762 & 764 VALLEY COURT

YARD EXPANSION FOR 84 LUMBER

SUBJECT: Response to Comments – 84 Lumber Yard
Expansion (SPR-2003-075).

84 LUMBER SIMPLE SUBDIVISION

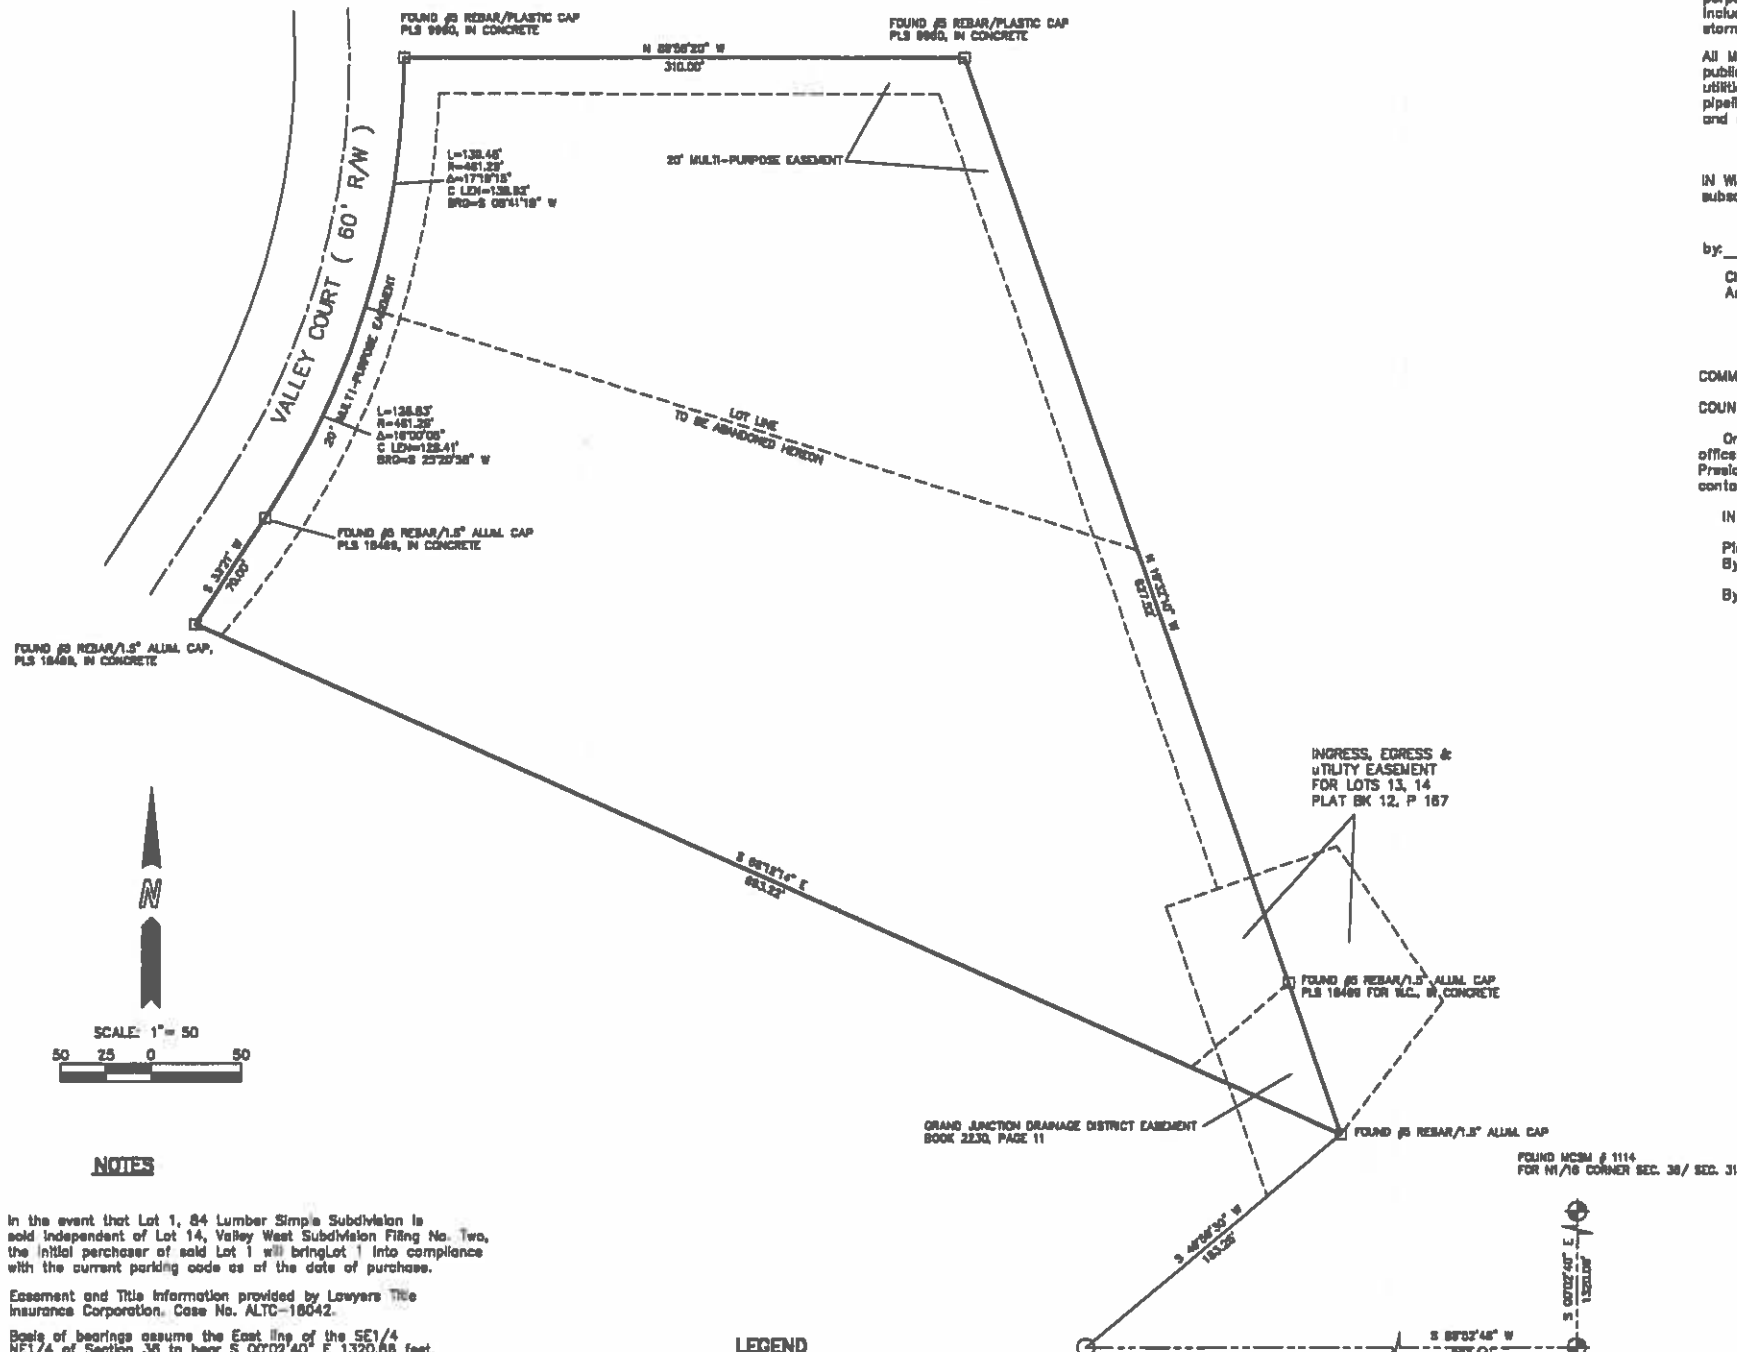
1. Revise the name of the subdivision in the lower right corner to reflect the correct name as used at the top of the sheet.
2. All letter height shall be 0.08 minimum.
3. The word "purchaser" is misspelled within the NOTES located on the left side of the sheet.

Response: All corrections have been made.

ISOFOOTCANDLE SITE PLAN

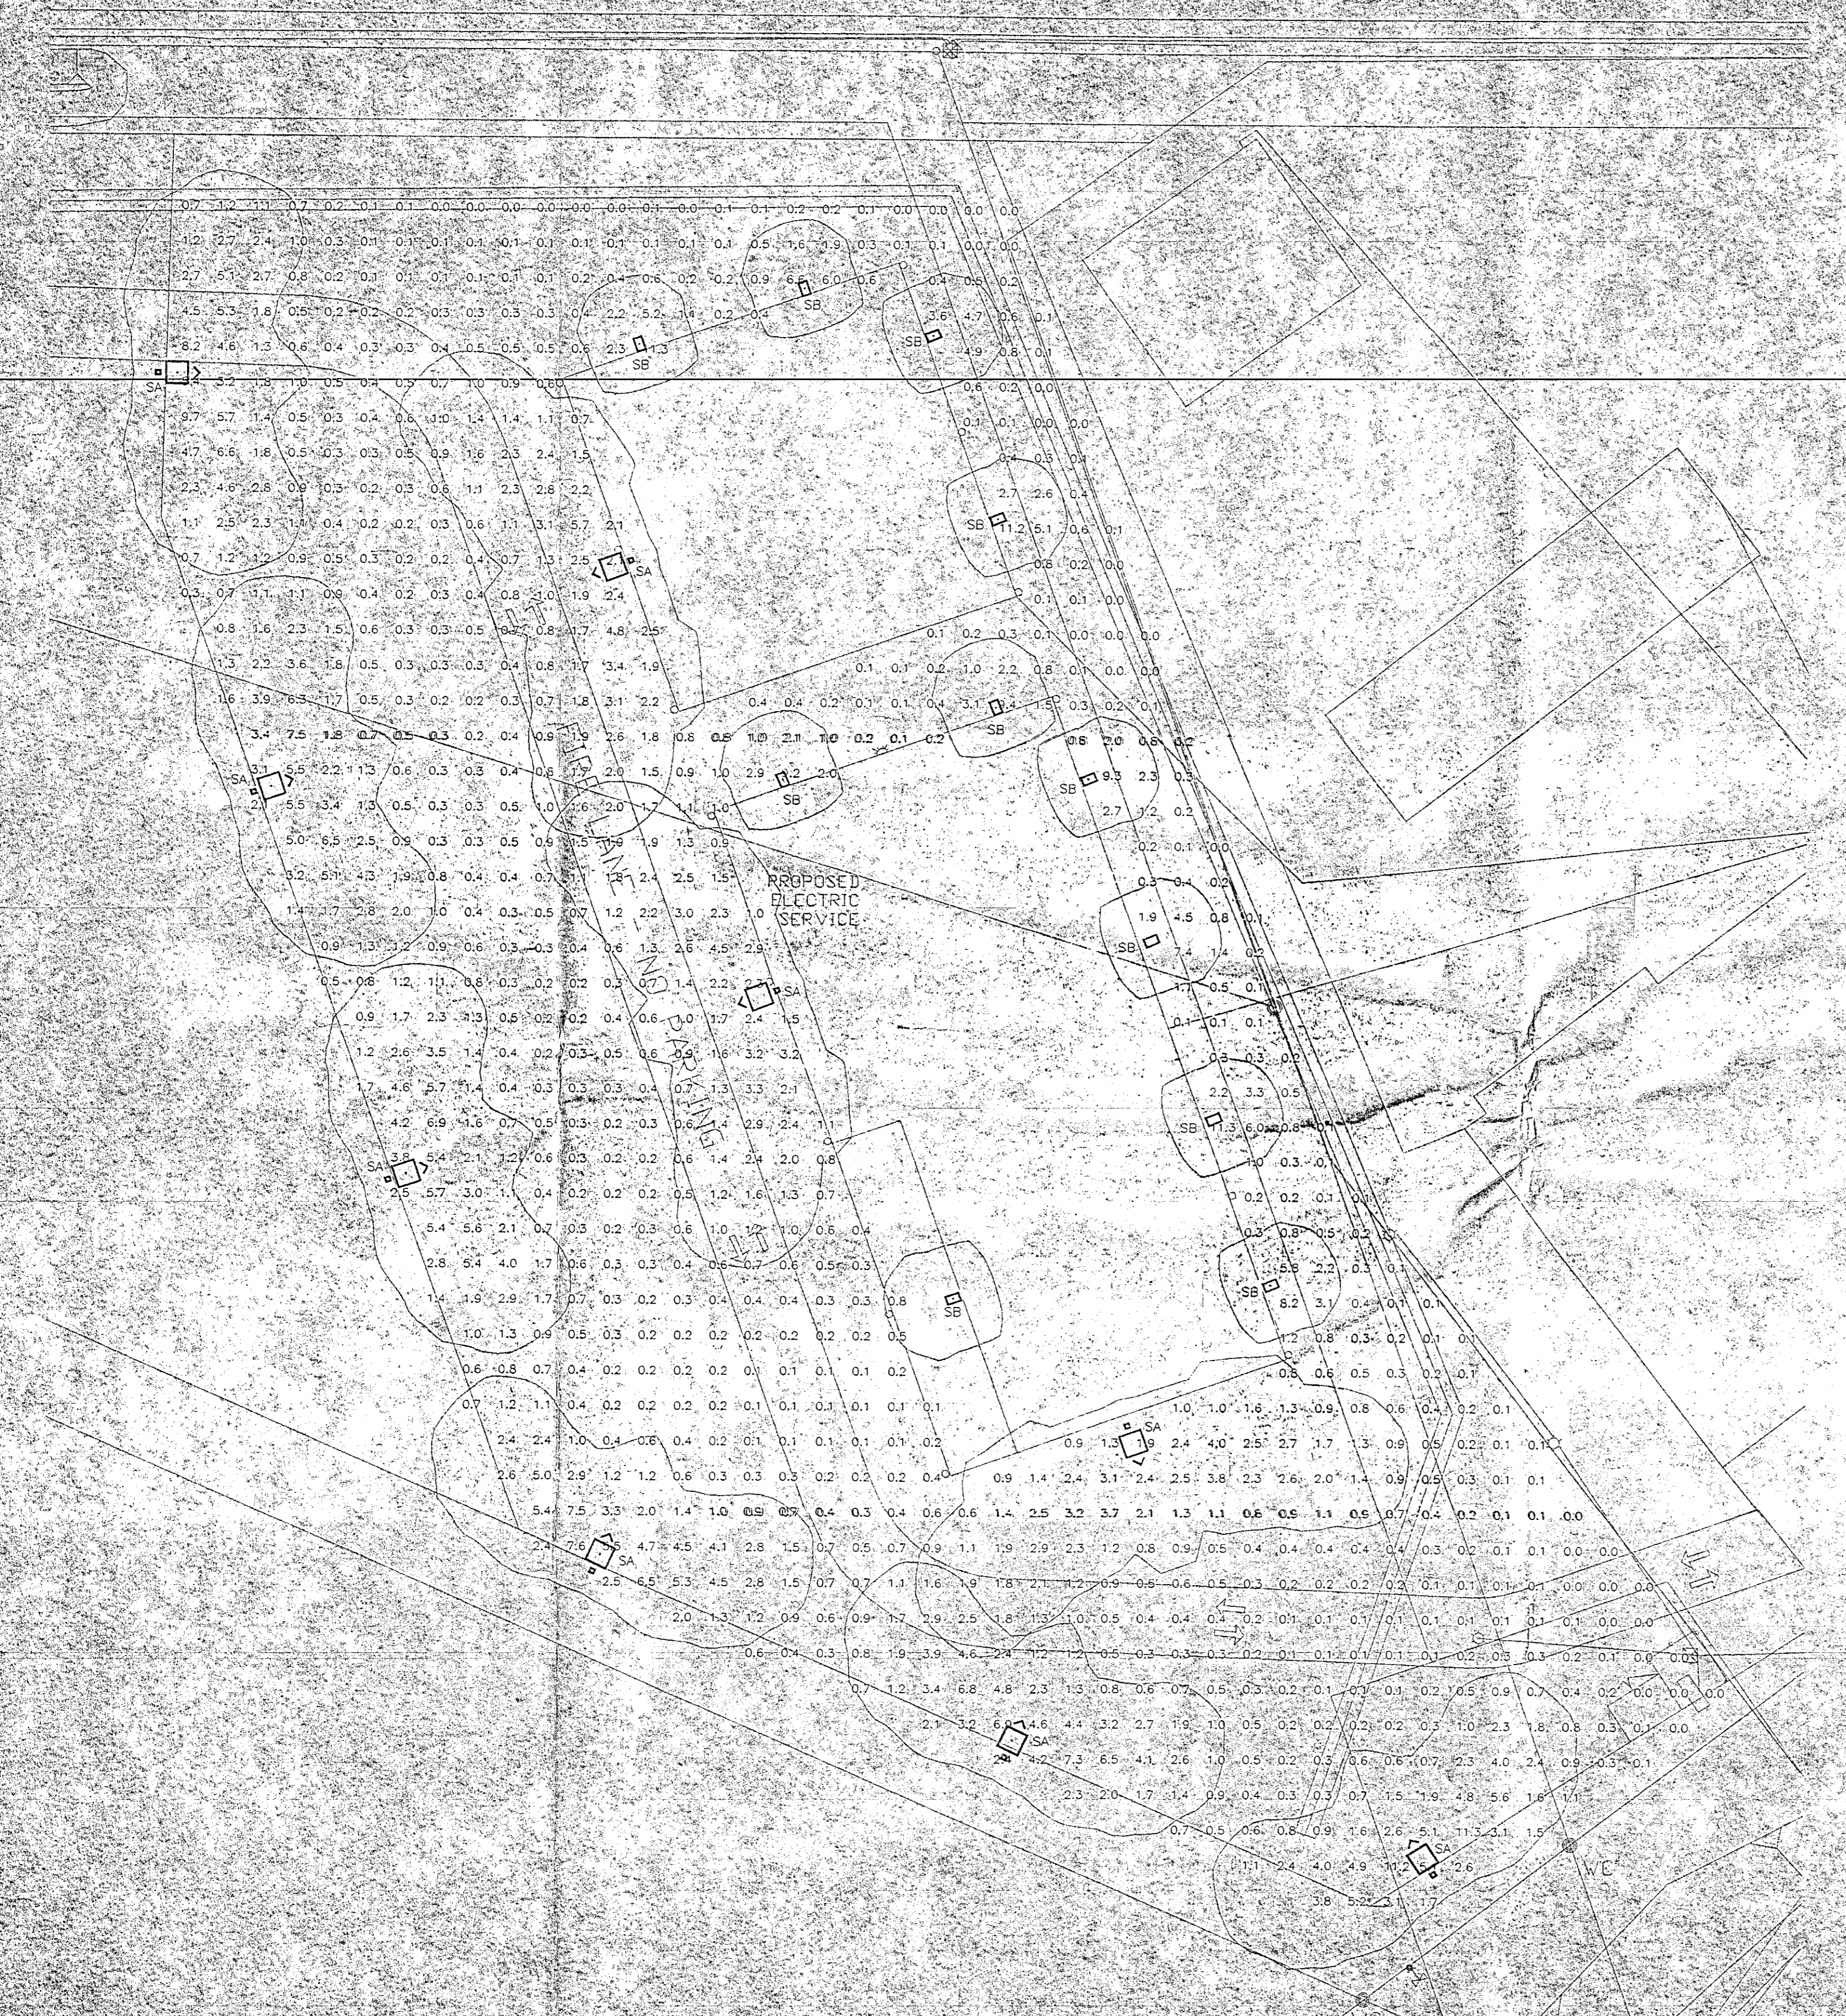
6. Provide a lighting plan that demonstrates that full cut-off fixtures will be supplied.

Response: A lighting plan has been prepared and is included with these responses.

84 LUMBER YARD EXPANSION
 UTILITY COMPOSITE
 PIECE HARDY LIMITED PARTNERSHIP

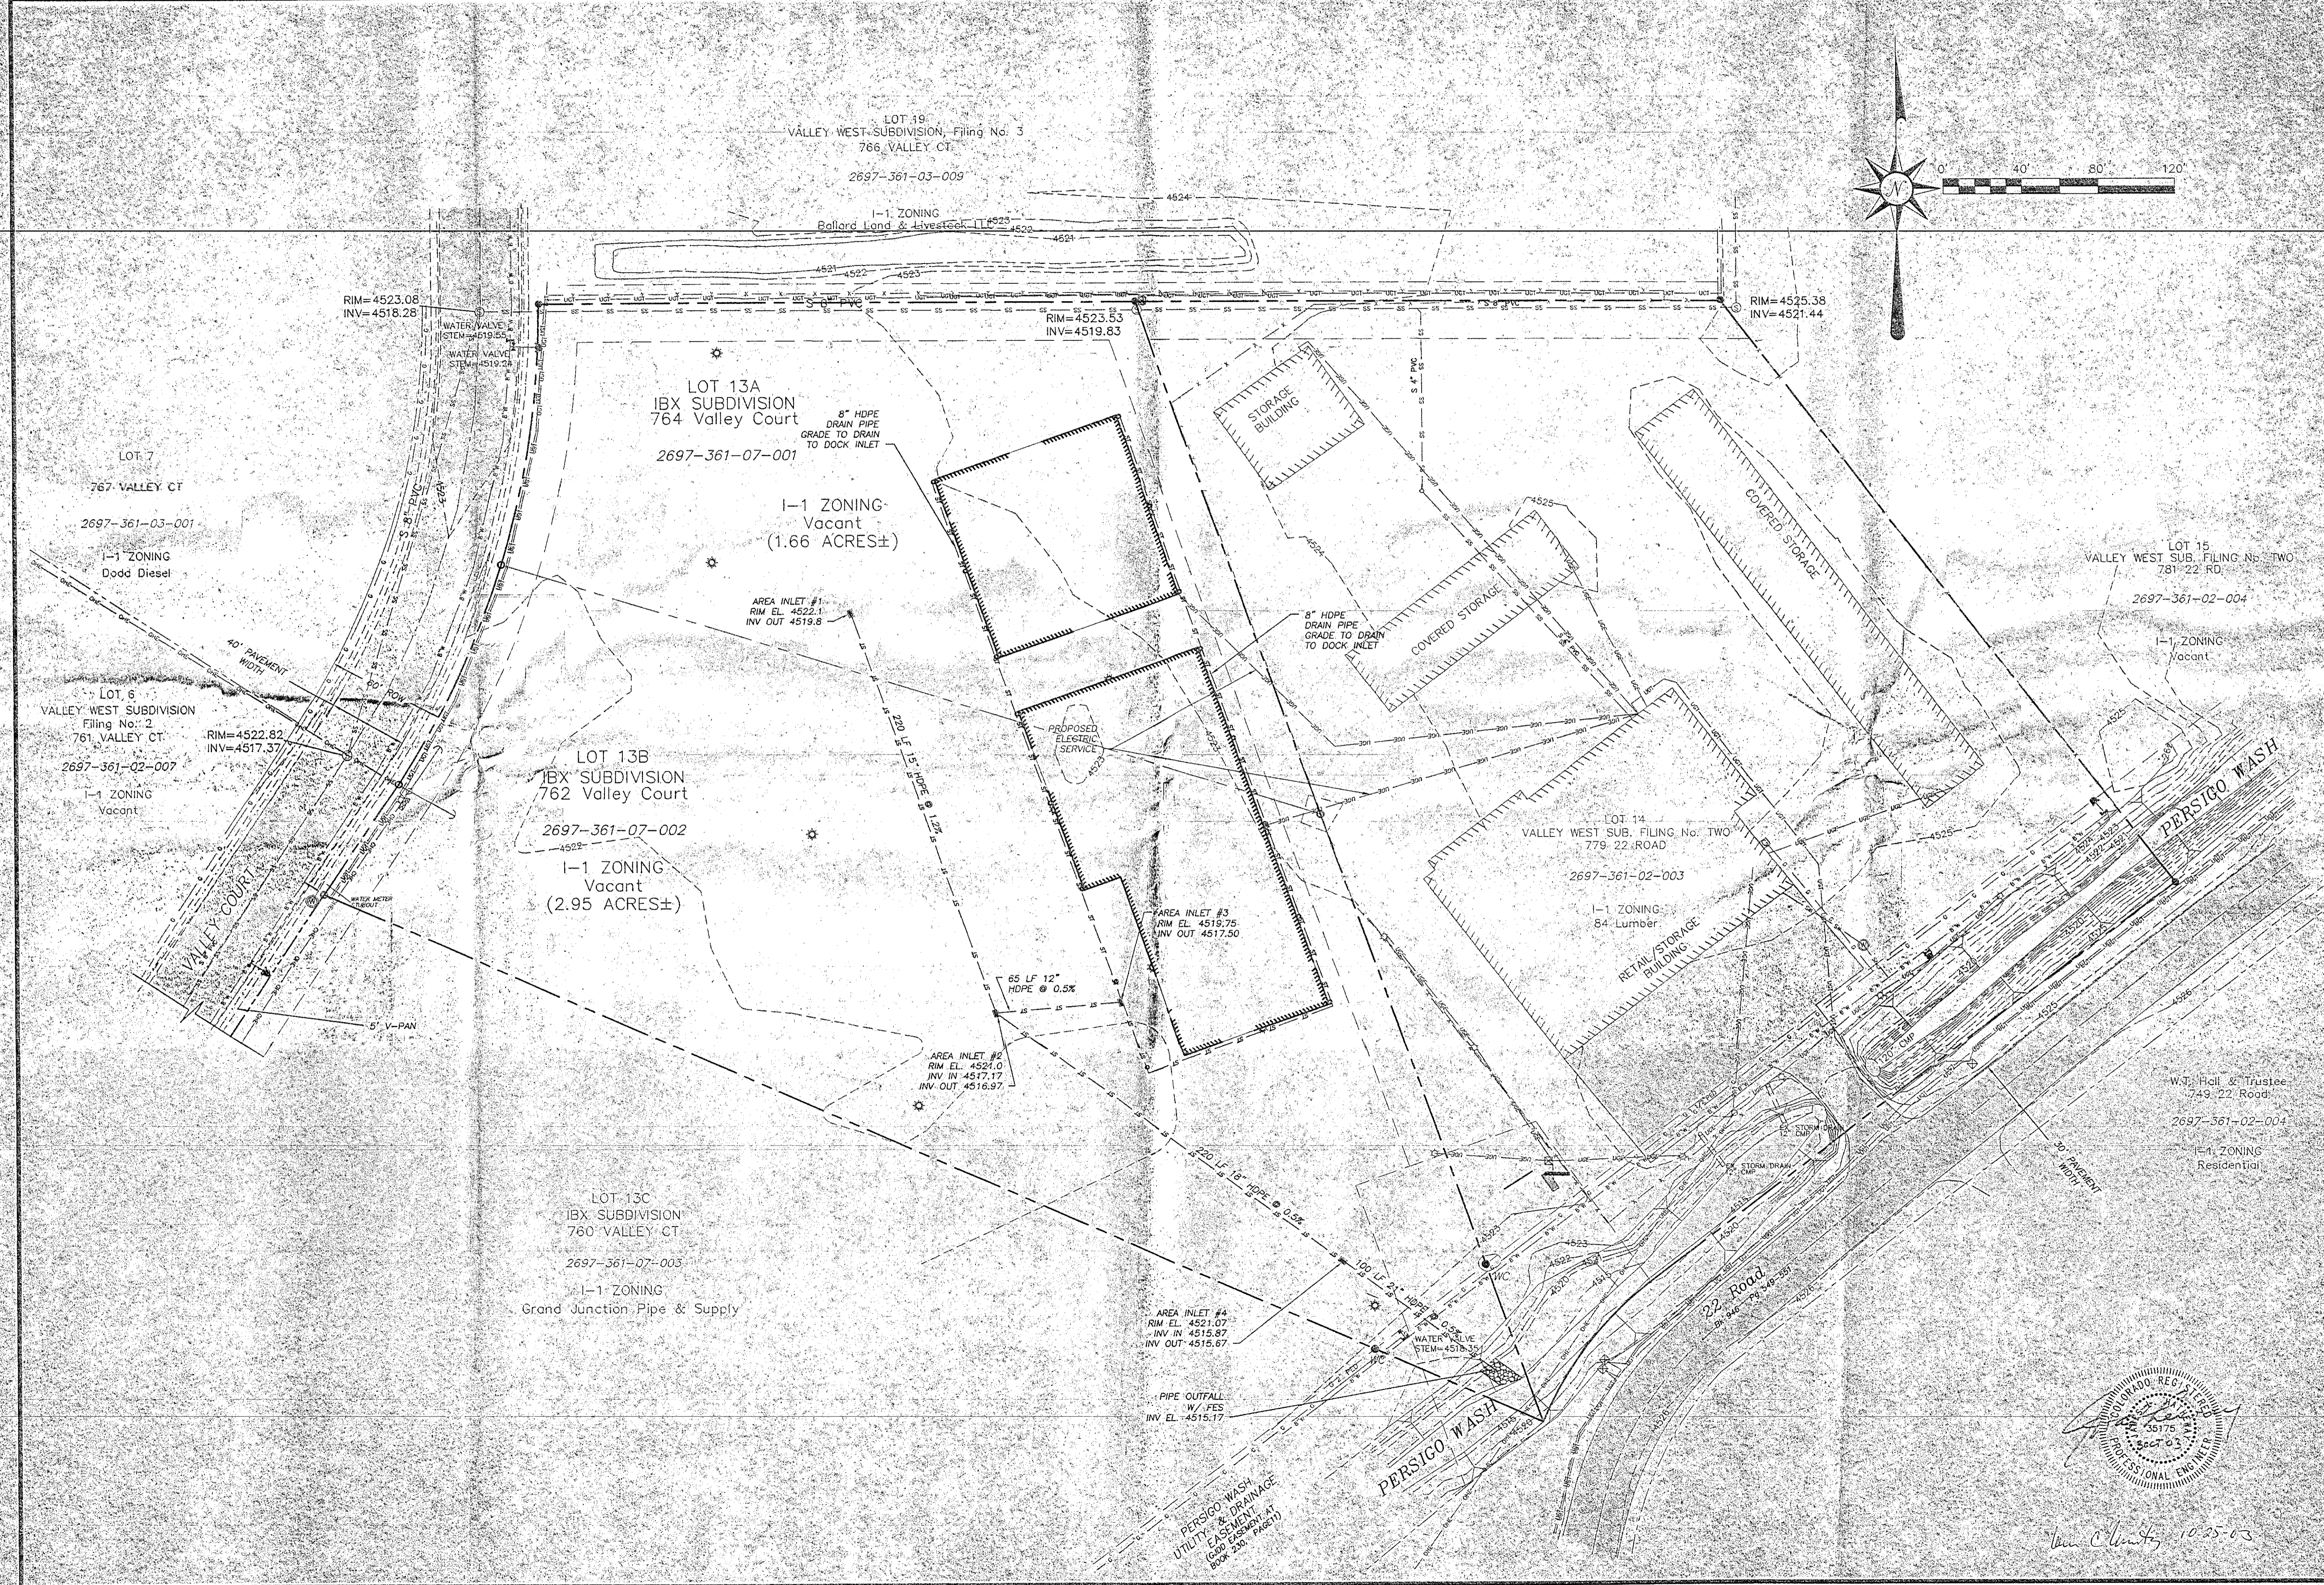
1. Sht UC 1: Show storm water utility on utility composite

Response: Proposed stormwater utility has been added to this drawing.
